**Historic Landmarks Committee
Hybrid In-Person & ZOOM Online Meeting
Wednesday, May 28 - 3:00 PM
Community Development Center, 231 NE 5th Street**

DATE: May 28, 2025
TO: Historic Landmark Committee Members
FROM: Matthew Deppe, Associate Planner
SUBJECT: DDR 2-24 (Downtown Design Review Waiver)
645 NE 3rd Street

DECISION, CONDITIONS, FINDINGS OF FACT AND CONCLUSIONARY FINDINGS OF THE PLANNING DEPARTMENT FOR THE REVIEW OF AN APPLICATION FOR DOWNTOWN DESIGN REVIEW FOR EXTERIOR ALTERATIONS TO AN EXISTING BUILDING AT 645 NE 3RD STREET WITHIN THE DOWNTOWN DESIGN AREA

1
1.0 EXISTING ROOF PATIO PLAN
1/4"=1'-0"

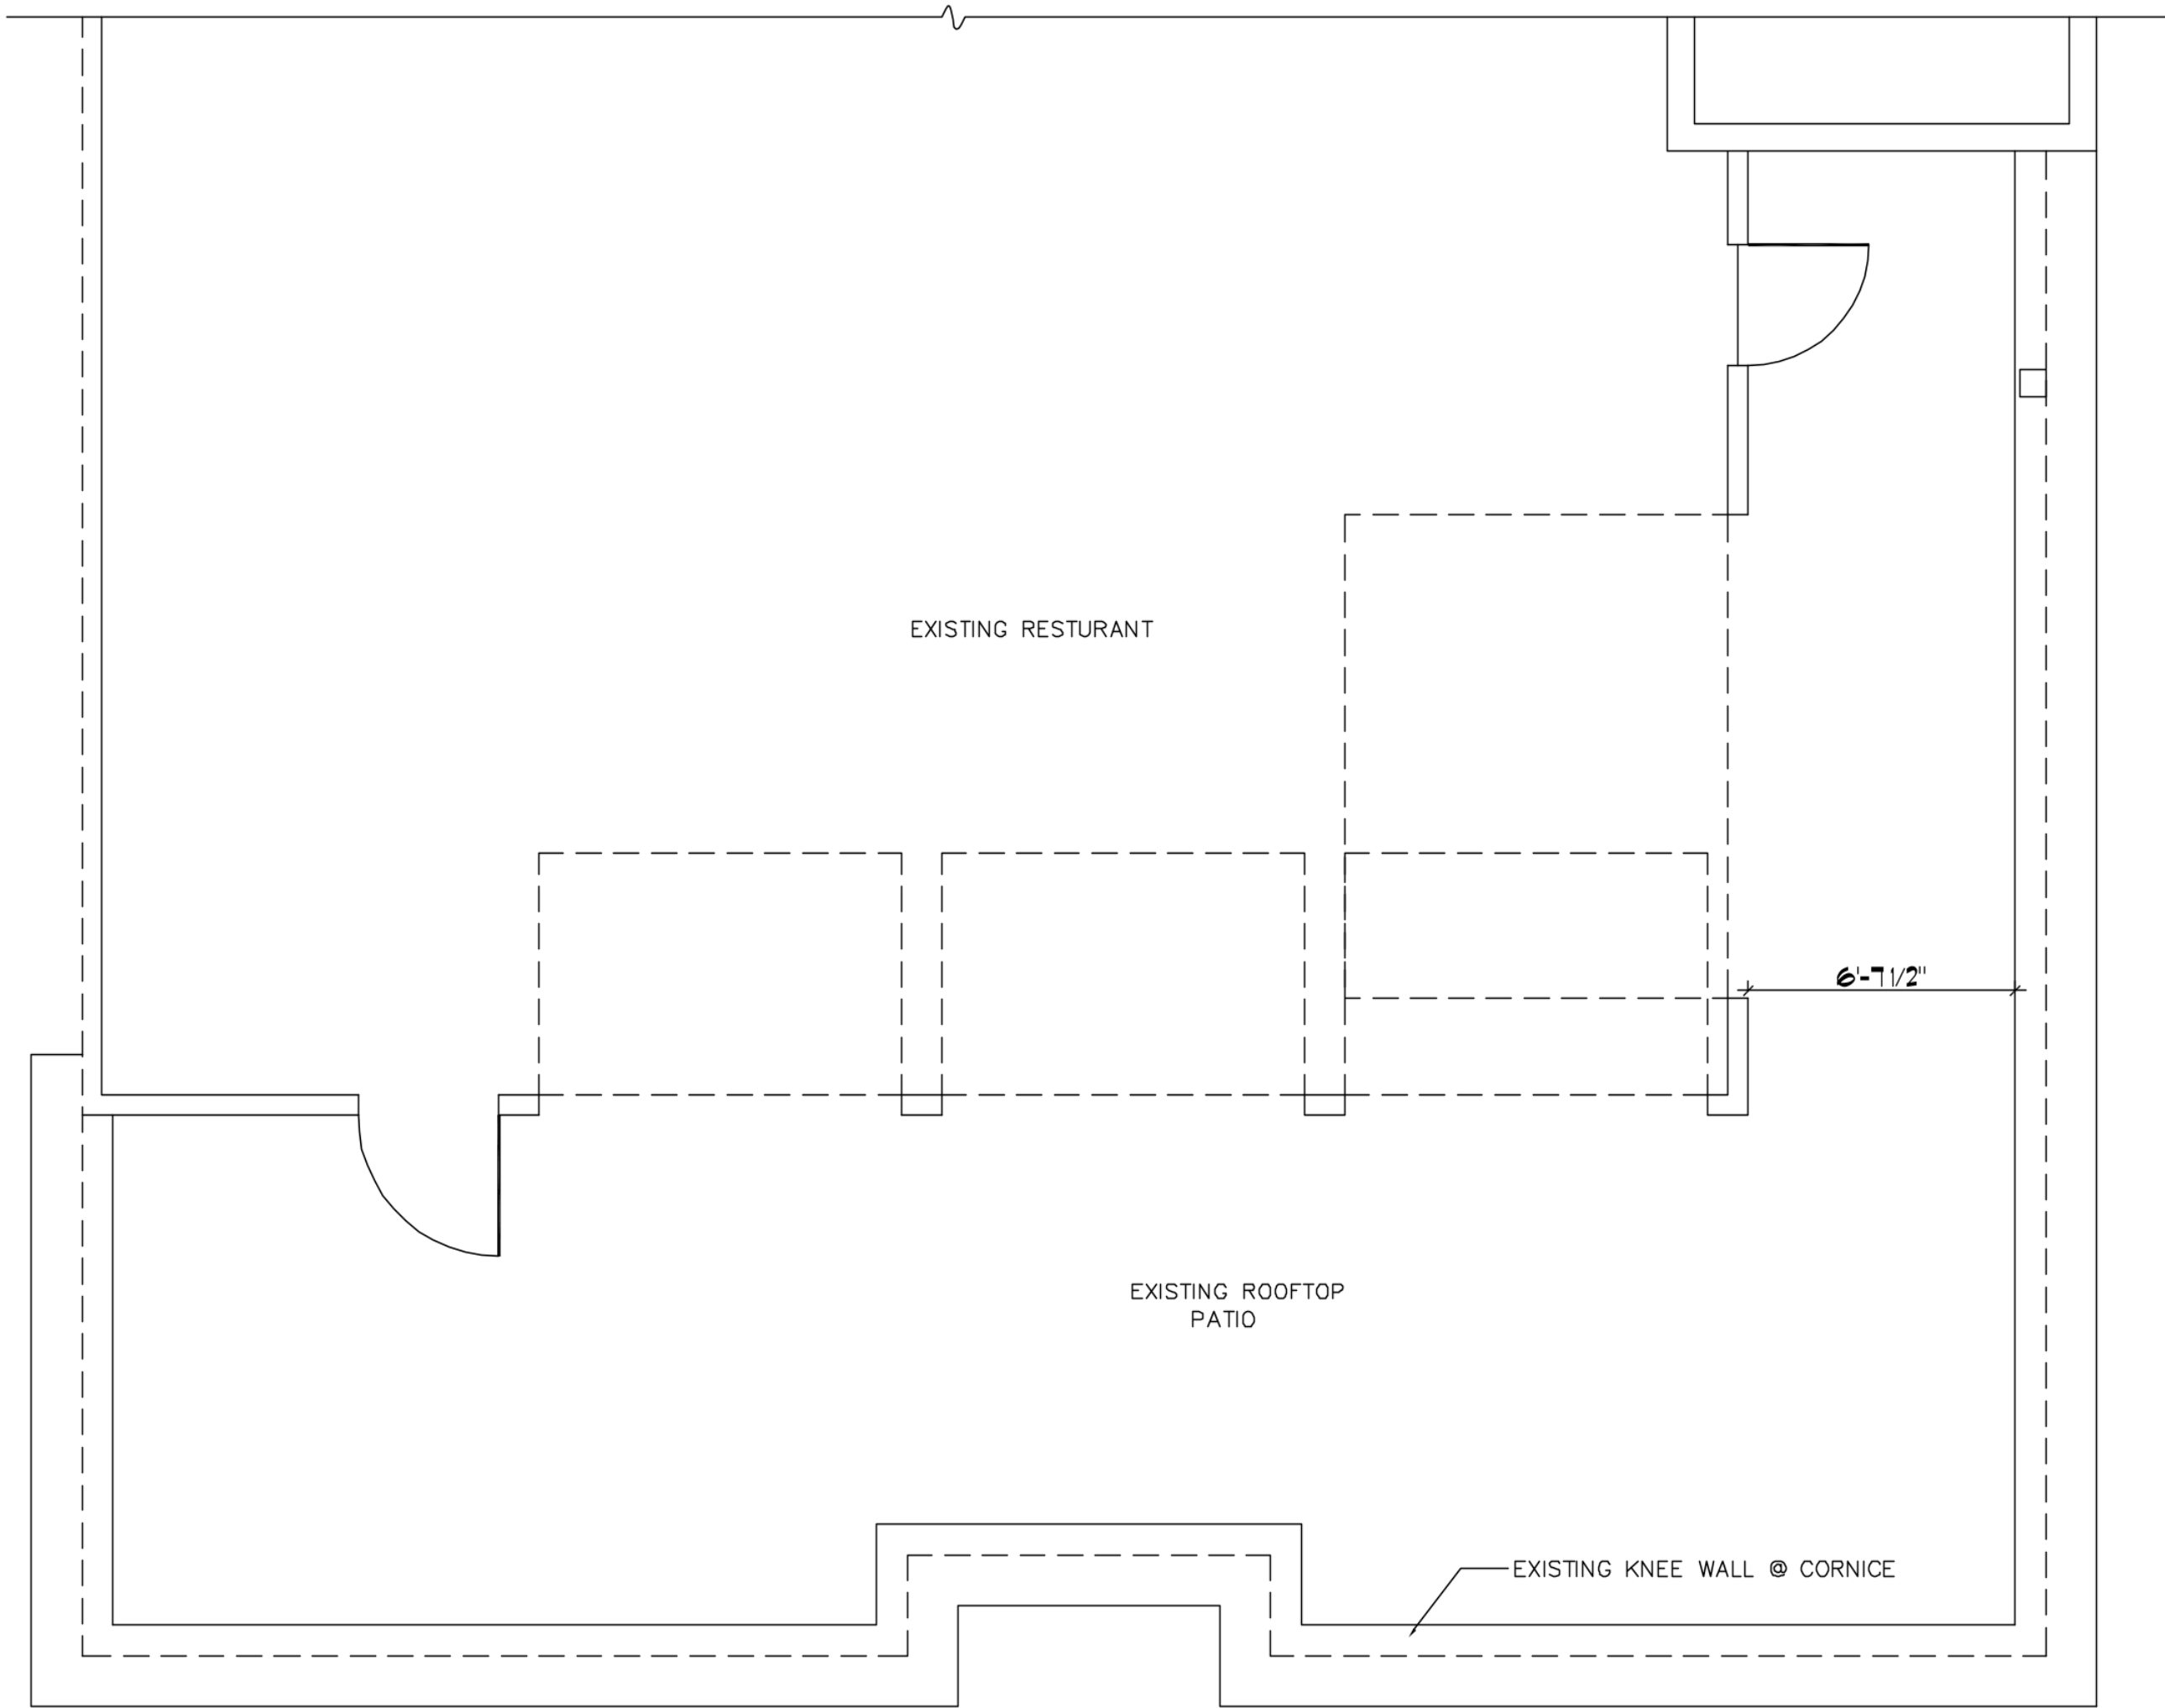
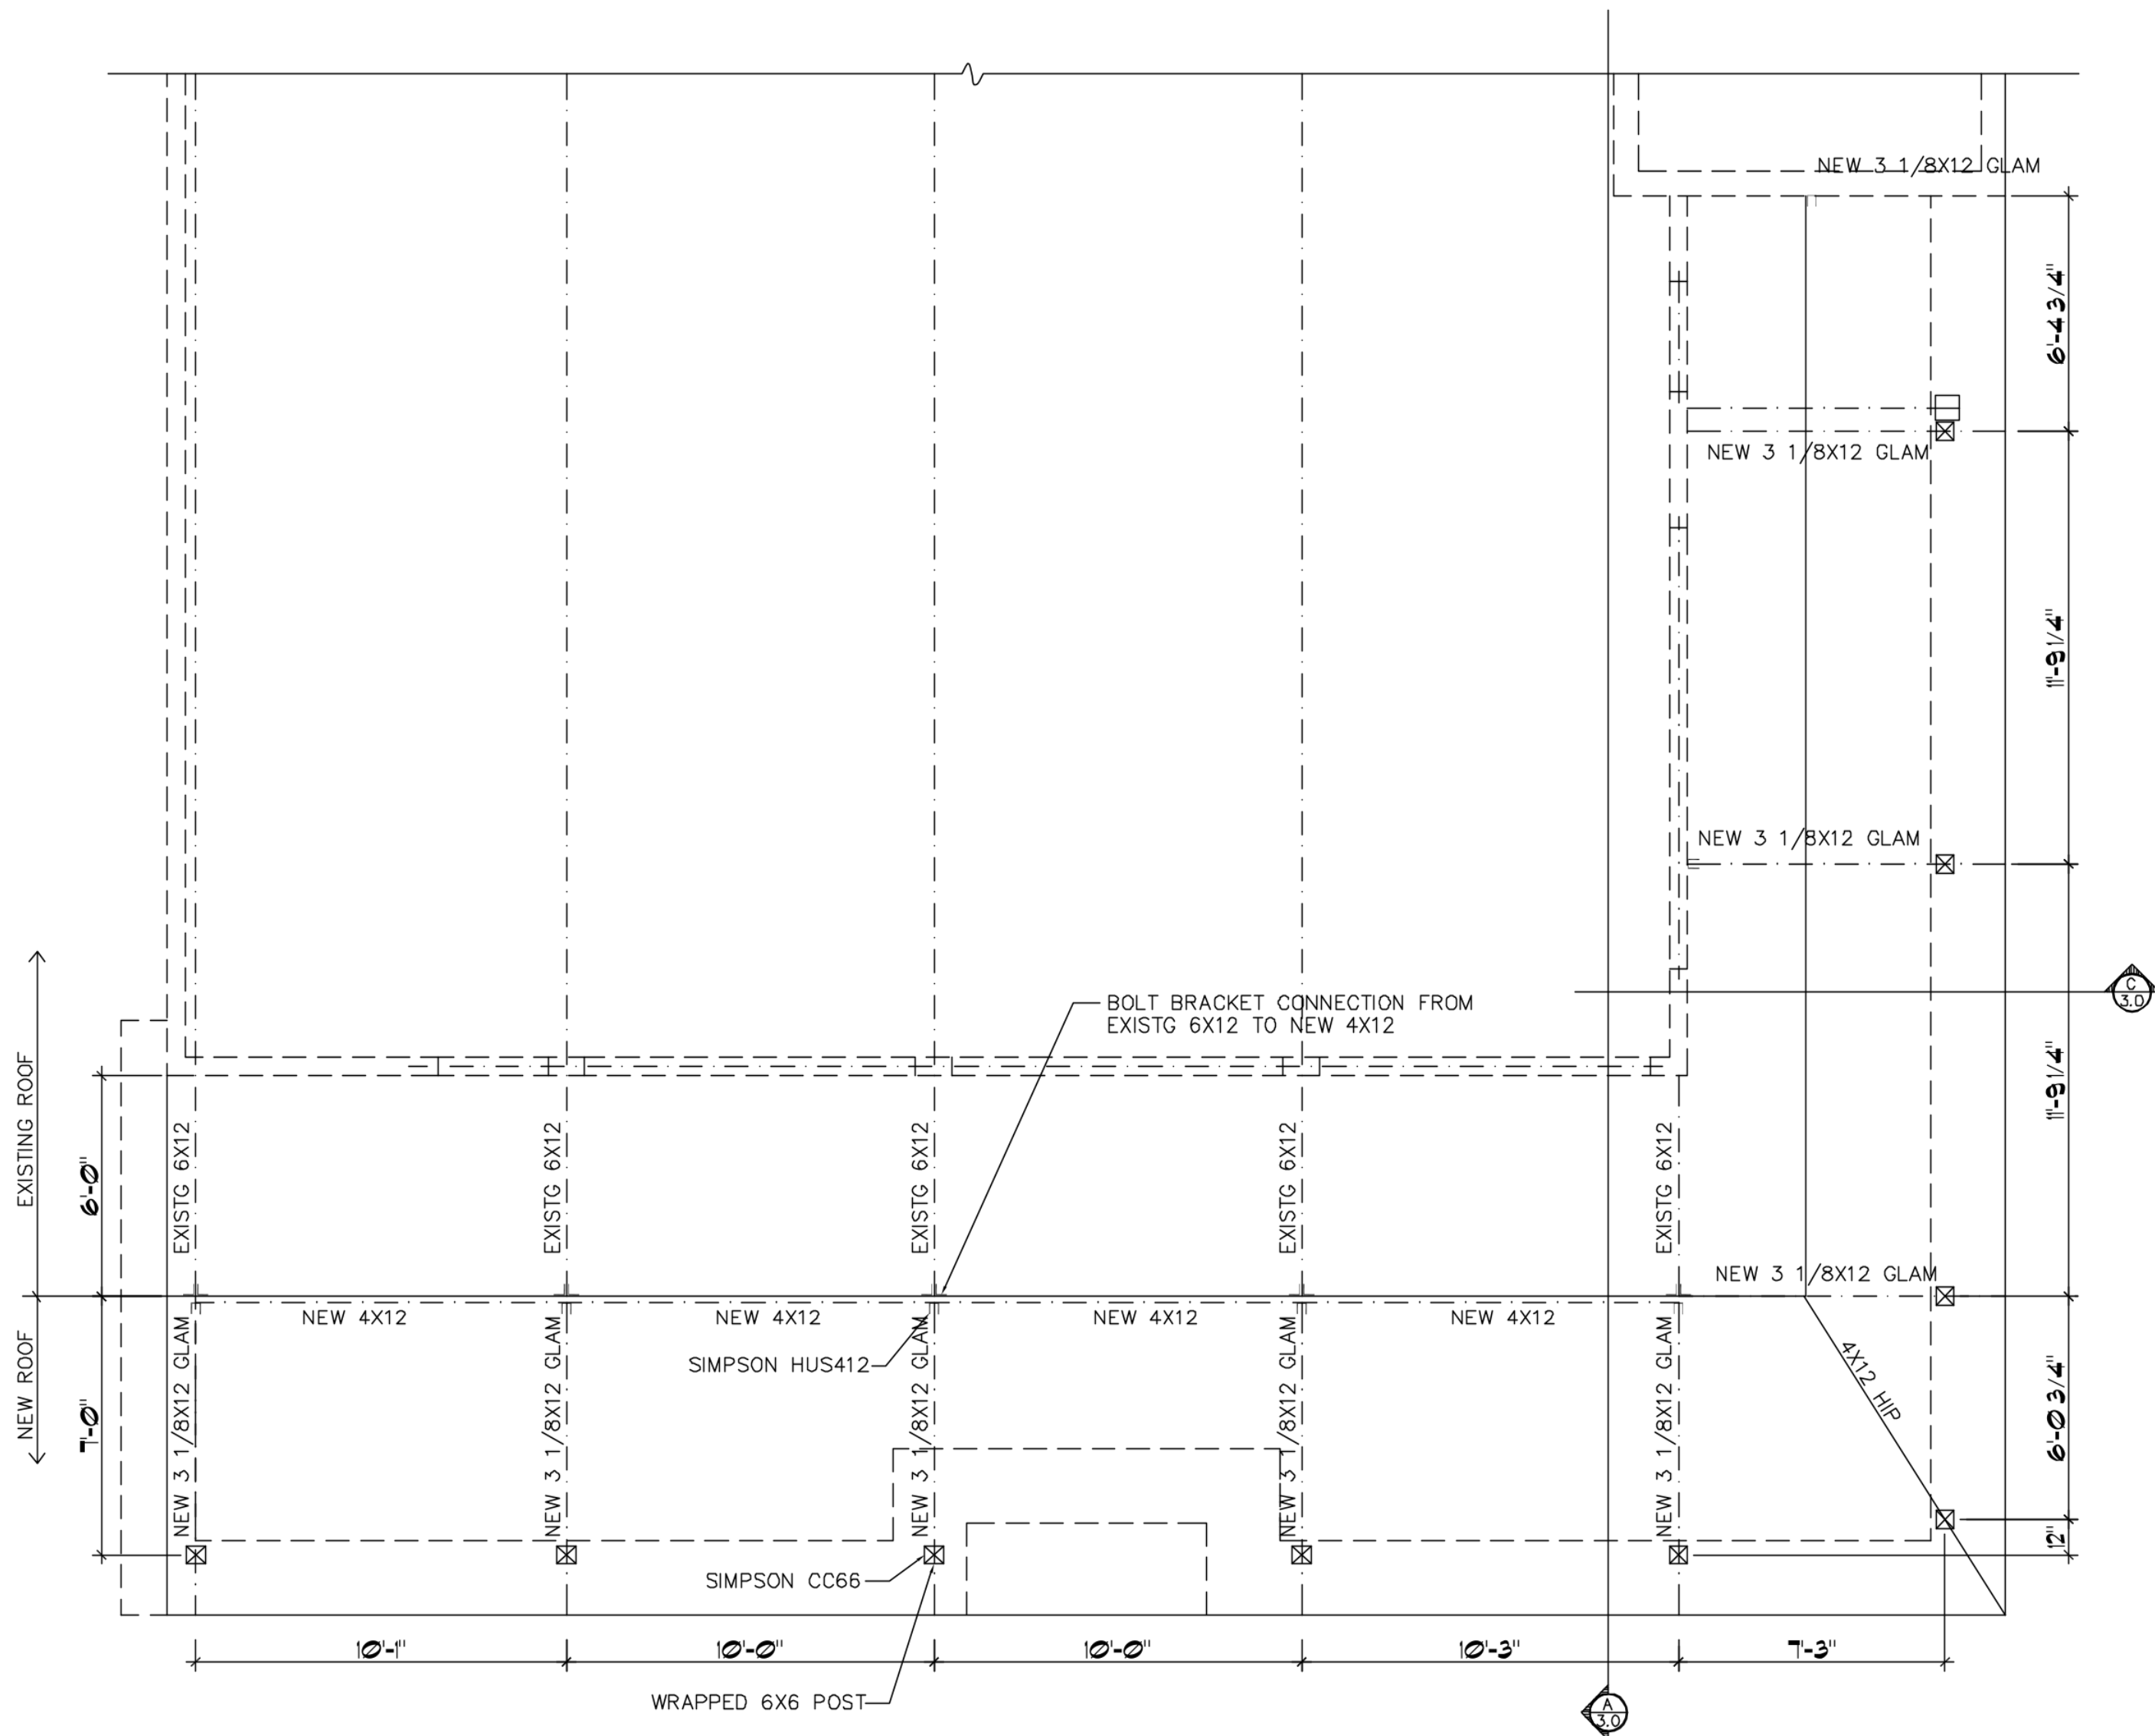
Staff recognizes that working with an existing design waiver poses a unique challenge. Staff also notes that it was the "not a true 3rd story" nature of the design that contributed to the approval of the design. Bringing the 3rd story out to the edges of building seems to undermine that basis of approval. This significant change brings into question whether the initial approval would have been granted if the design would have continued to edge of the building. This location is more visible at the street level and extends the use of the prohibited materials. Generally, painted wood is limited to window frames and door frames on the existing historic structures downtown. It is the staff's understanding that that is the sole intended application of that listed material.

Extending the wood siding ceiling materials out to the edge of the building would also increase the visibility of a prohibited downtown material to the street below. The applicant provides the conclusion that no other designs would work but does not provide any evidence supporting that conclusion.

1. That the applicant shall submit building permit applications prior to completing any work. The construction plans submitted with the building permit applications will be reviewed by the Planning Director for consistency with the written narrative, exhibits, drawings, and renderings submitted for review by the Historic Landmarks Committee, along with any revisions to respond to other conditions of approval.
2. The applicant will receive a design review waiver for Section 17.59.050(B)(3)(e).
3. The applicant will receive a design review waiver for Section 17.59.050(C)(2)(a).
